2026 Summary of Revisions

City of Bismarck Construction Specifications for Municipal Public Works Improvements

The City of Bismarck has revised the Construction Specifications for Municipal Public Works Improvements for 2026.

MANHOLE CASTING STANDARD ADJUSTMENT

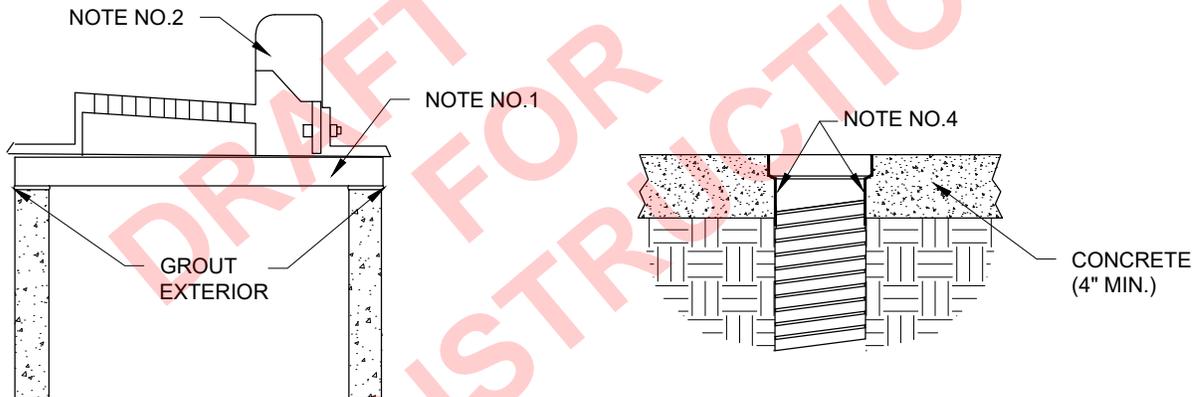
REMOVED I/I BARRIER
AND CLARIFY
